**From:** Carver, Beverley (DEQ)  
**Sent:** Tuesday, July 12, 2016 2:35 PM  
**To:** 'Ronald Harrison (rharrison@vapgc.com)'  
**Subject:** VPGC, LLC, VPDES Permit No. VA0002313, Rockingham County

**Re:** Major Permit Modification  
VPGC, LLC, VPDES Permit No. VA0002313, Rockingham County

Schematic of Water Flow for  
VPGC, LLC Hinton, Va

SCHMATIC OF WATER FLOW FOR  
VIRGINIA POULTRY GROWERS COOP  
HINTON, VIRGINIA

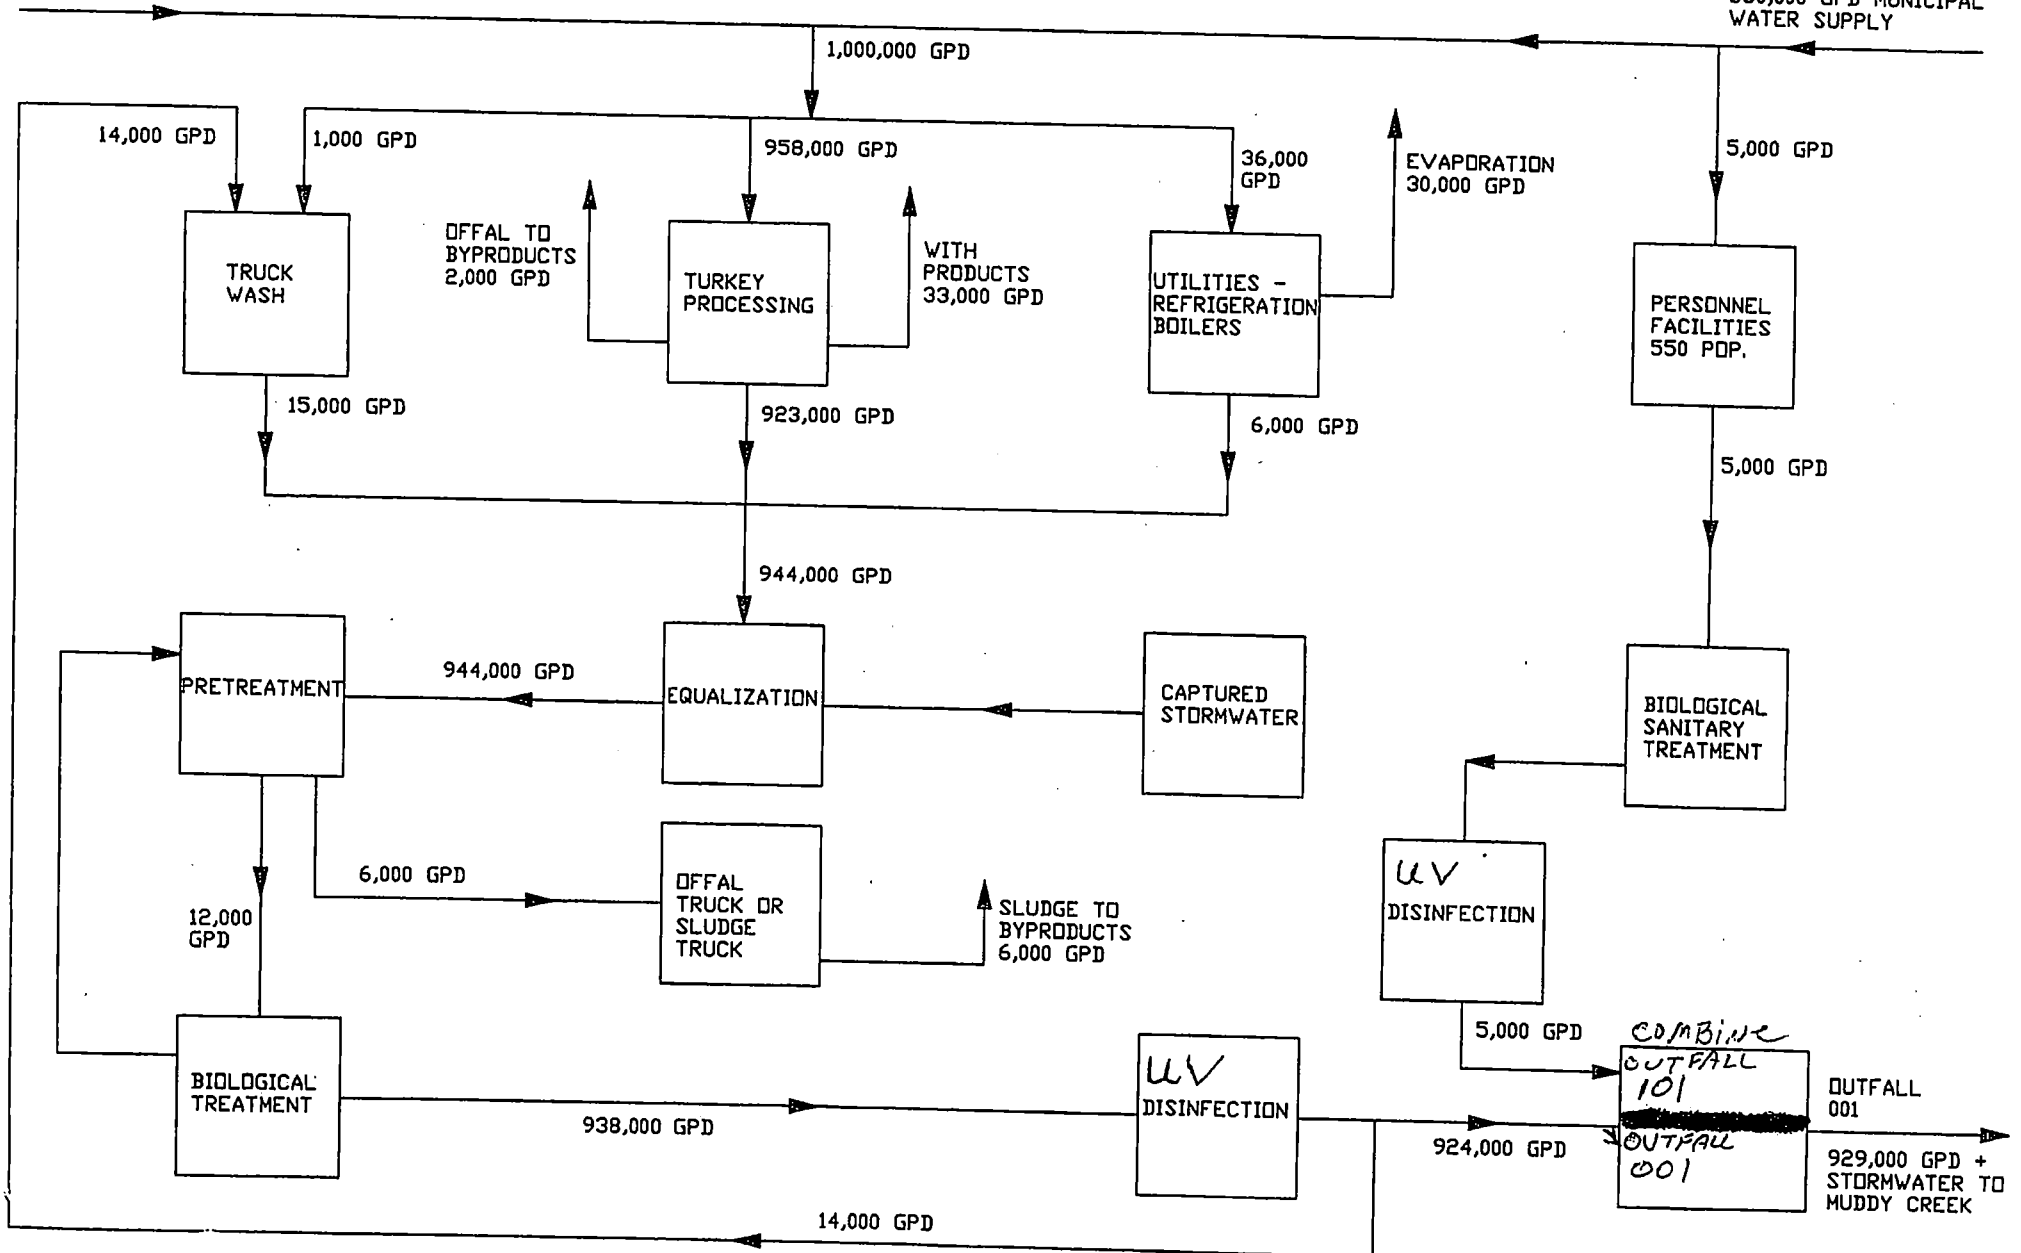
Can you have someone prepare an updated schematic of water flow diagram? Attached is a drawing based on my understanding of the updated configuration.

Do you expect that the outfall 102 flow will remain at 1.10 MGD or go to the 1.52 MGD flow when the production facility goes online? Will the LWK increase when the new production facility goes online? Why is so much more raw water storage needed?

Yes, Will send to you when done. Yes the outfall will remain at 1.10 MGD when production goes online. The kill can go up 15,000 more per week and in the future they are looking at 50 pound turkeys instead of the 42 pounds now. If they run organic birds on Monday then they will not dump the chillers but every Friday which will save 300,000 gals of water per week so should keep us around 900,000 plus storm water per day.

The raw more water storage was due to collecting of 100% storm water before that had birds left on lot because of running out of room in old basins.

SITE MAP &amp; DRAINAGE PERMIT MAP

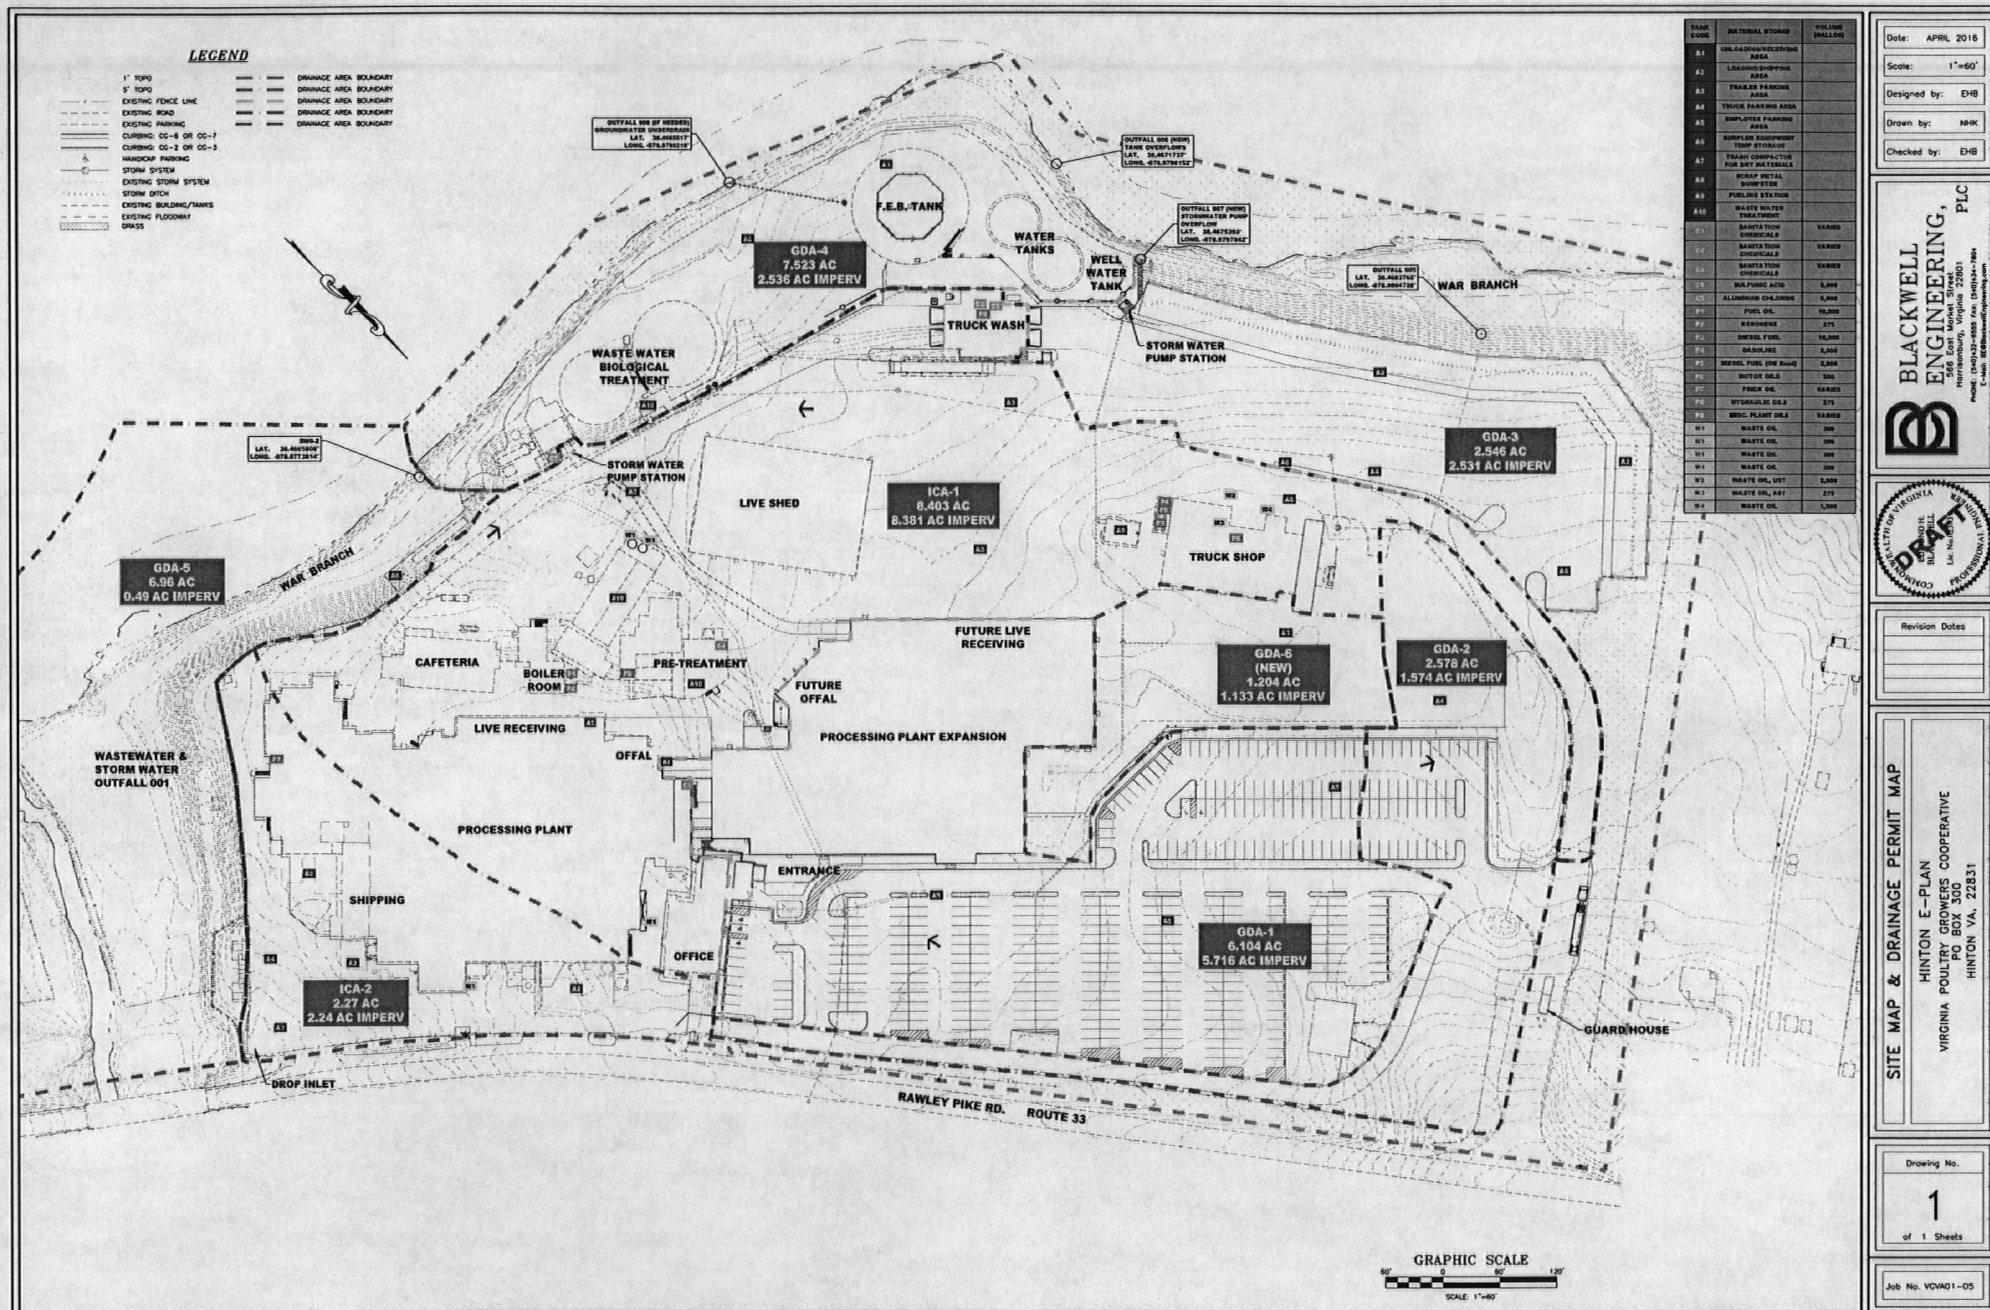
The large plan sheet you submitted with the permit modification request from Blackwell Engineering titled Site Map & Drainage Permit Map has drainage areas and labels. I will need to discuss the new outfalls and what drains to the new outfalls. An updated Environmental Plan would be helpful.

If the plan has not been updated, then I will need a table listing the drainage areas to each outfall and a description.
